SUBJECT: TURKEY POINT NUCLEAR GENERATING, UNIT NOS. 3 AND 4 - STAFF ASSESSMENT OF INFORMATION PROVIDED PURSUANT TO TITLE 10 OF THE *CODE OF FEDERAL REGULATIONS* PART 50, SECTION 50.54(f), SEISMIC HAZARD REEVALUATIONS FOR RECOMMENDATION 2.1 OF THE NEAR-TERM TASK FORCE REVIEW OF INSIGHTS FROM THE FUKUSHIMA DAI-ICHI ACCIDENT AND STAFF CLOSURE OF ACTIVITIES ASSOCIATED WITH RECOMMENDATION 2.1, "SEISMIC" (CAC NOS. MF3709 AND MF3710)

STAFF ASSESSMENT BY THE OFFICE OF NUCLEAR REACTOR REGULATION  
RELATED TO SEISMIC HAZARD AND SCREENING REPORT  
TURKEY POINT NUCLEAR GENERATING, UNIT NOS. 3 AND 4  
DOCKET NOS. 50-250 AND 50-251

Figure 3.3-1 Plot of Staff's and Licensee's Base Case Shear-Wave Velocity Profiles for the A) upper 500 ft depth and B) full profile at the Turkey Point site

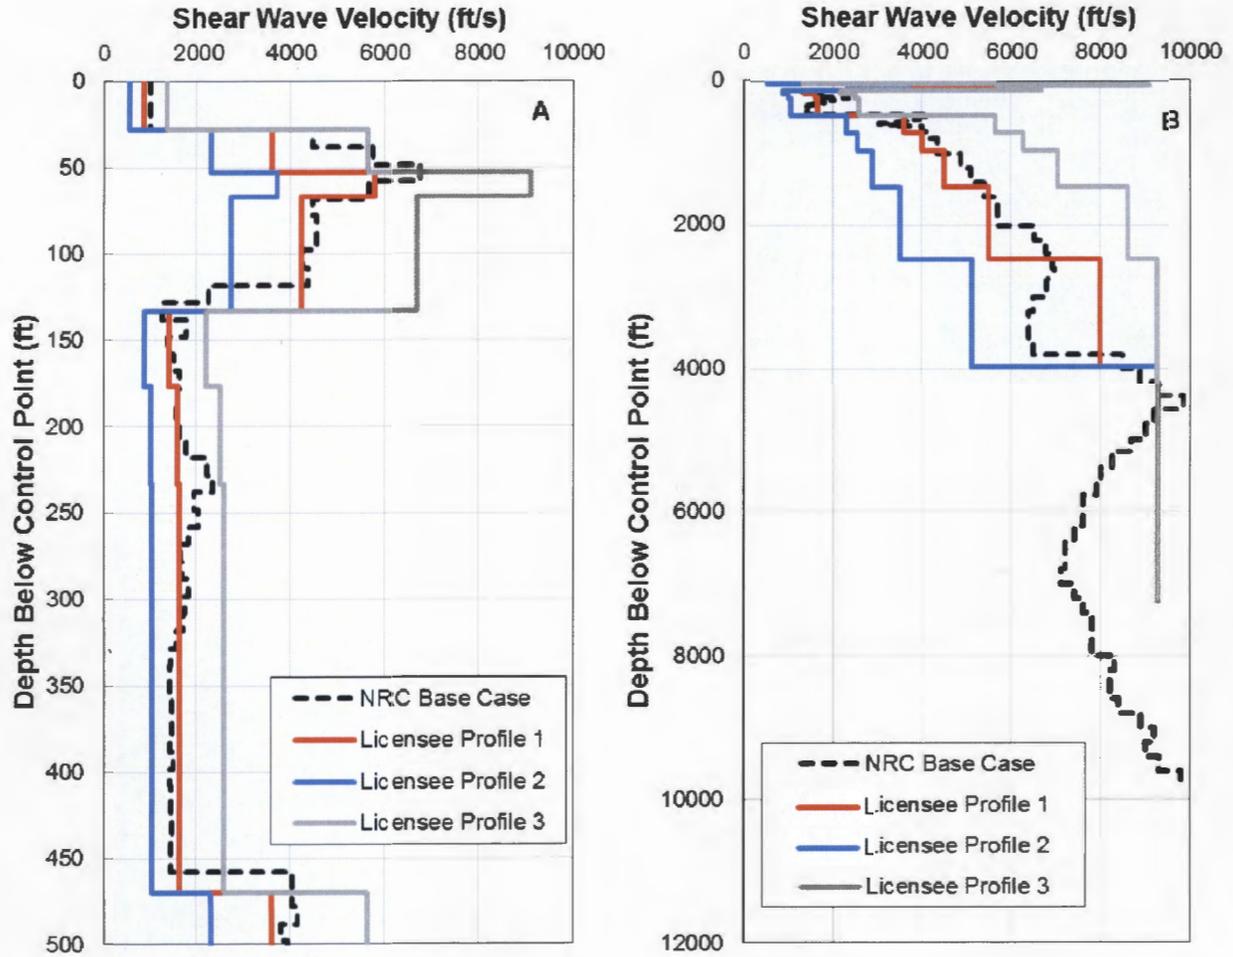
For its confirmatory site response analysis, the NRC staff essentially used the base case shear-wave velocity profile developed for the Turkey Point Unit Nos. 6 and 7 COL (FPL, 2014). The NRC staff notes that the close proximity of Turkey Point Unit Nos. 3 and 4 to the proposed site for Turkey Point, Unit Nos. 6 and 7, as well as the relative uniformity of the site geology, supports the use of the more recent shear wave velocity measurements for use at the older units. For the upper 20 ft [6 m] of fill material, the staff used a shear wave velocity of 1,000 ft/sec [305 m/s], which is slightly higher than the shear wave velocity used by the licensee of 896 ft/sec [273 m/s] for the fill. Below 20 ft [6 m], the staff used the shear wave velocity profile developed for Turkey Point, Unit Nos. 6 and 7, which extends to a depth of about 10,000 ft [3050 m] before reaching the base or reference rock velocity of 9,200 ft/sec [2,800 m/s]. Figure

3.3-1 of this assessment shows the staff's base case velocity profile as well as the licensee's three base case profiles. The licensee extended its three base case profiles down to approximately 4,000 ft [1,219 m] while the NRC staff, using the velocity profile for the proposed Unit Nos. 6 and 7 site has a much deeper profile. In addition, due to the extensive subsurface geophysical profiling performed for the proposed site, the NRC staff used only a single base case velocity profile rather than develop three profiles.

Figure 3.3-2 Plot Comparing the Staff's and the License's Median Amplification Functions and Uncertainties for the Turkey Point site using the Base Case velocity profile and upper range material non-linearity, A) Rock PGA = 0.01 g, B) Rock PGA = 0.10 g.

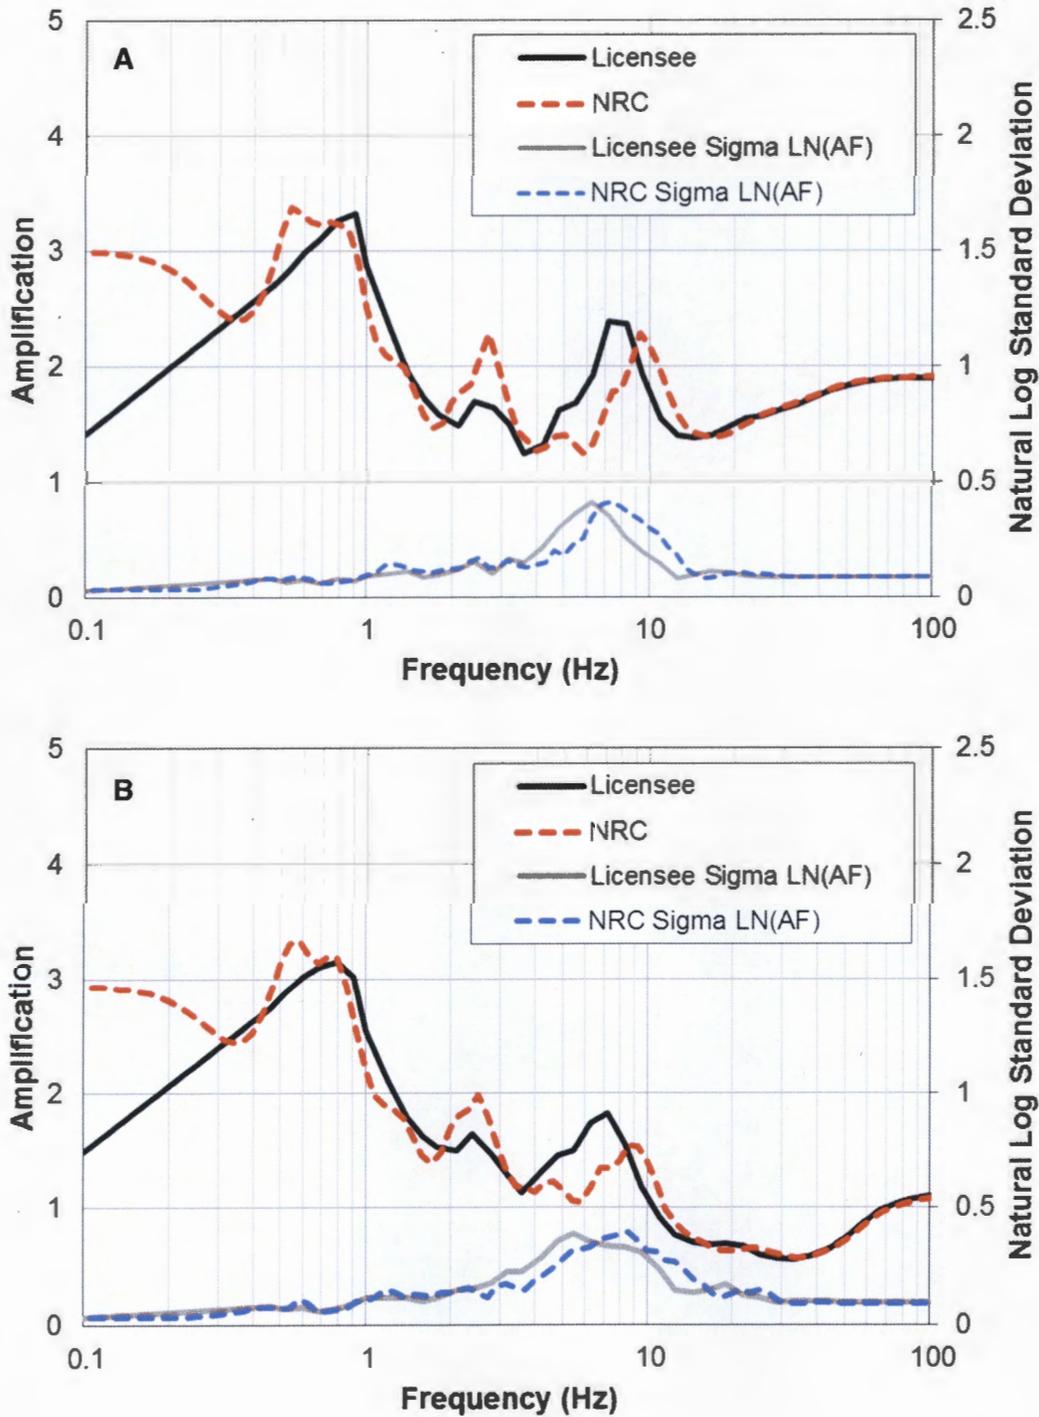
Figure 3.3-2 of this assessment shows a comparison of the NRC staff's and licensee's median site amplification functions and uncertainties ( $\pm 1$  standard deviation) for two of the eleven input loading levels and Figure 3.3-3 of this assessment shows a comparison of the licensee's and the staff's control point hazard curves. As shown in Figure 3.3-2, the staff's and licensee's amplification factors are very similar. In addition, the NRC staff's control point hazard curves, shown in Figure 3.3-3, are similar to the licensee's curves with the exception of the licensee's 1 Hz hazard curve, which is slightly higher than the staff's 1 Hz curve. Appendix B of the SPID provides guidance for performing site response analyses, including capturing the uncertainty for sites with less subsurface data; however, the guidance is neither entirely prescriptive nor comprehensive. As such, various approaches in performing site response analyses, including the modeling of uncertainty, are acceptable for the 50.54(f) response.

In summary, the NRC staff concludes that the licensee's site response was conducted using present-day guidance and methodology, including the NRC-endorsed SPID. The NRC staff performed independent calculations, which confirmed that the licensee's amplification factors and control point hazard curves adequately characterize the site response, including the uncertainty associated with the subsurface material properties, for the Turkey Point site.

Figure 3.4-1 Comparison of the Staff's GMRS with Licensee's GMRS and SSE for the Turkey Point site.

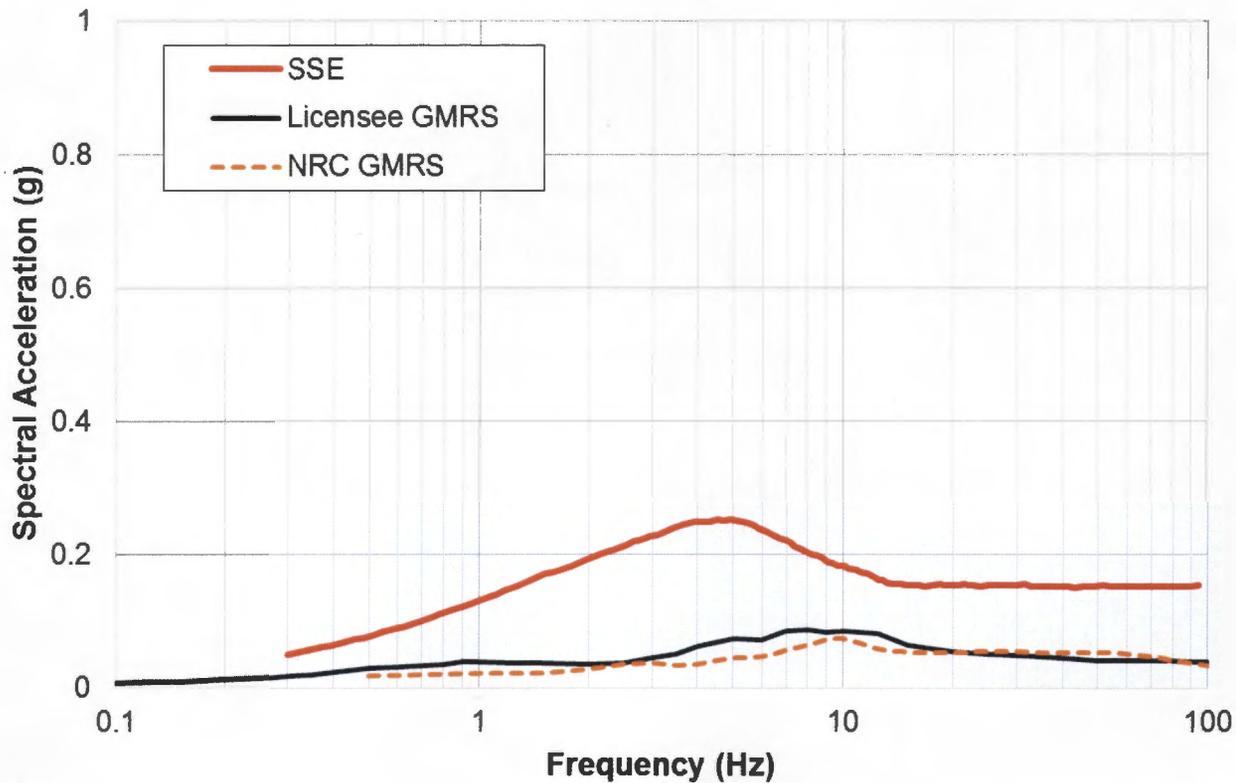
The NRC staff independently obtained the  $10^{-4}$  and  $10^{-5}$  UHRS using the results of its confirmatory PSHA and site response calculations described in Sections 3.2 and 3.3 of this staff assessment, respectively. Figure 3.4-1 of this assessment shows a comparison of the GMRS determined by the licensee to that determined by the NRC staff. As shown in Figure 3.4-1, the licensee's GMRS shape is generally similar to the licensee's GMRS across the entire frequency range.

The NRC staff confirms that the licensee used the present-day guidance and methodology outlined in RG 1.208 and the SPID to calculate the horizontal GMRS as requested in the 50.54(f) letter. The NRC staff performed both a PSHA and site response confirmatory analysis and achieved results consistent with the licensee's horizontal GMRS. As such, the NRC staff concludes that the GMRS determined by the licensee adequately characterizes the reevaluated hazard for the Turkey Point site. Therefore, this GMRS is suitable for use in subsequent evaluations and confirmations, as needed, for the response to the 50.54(f) letter.
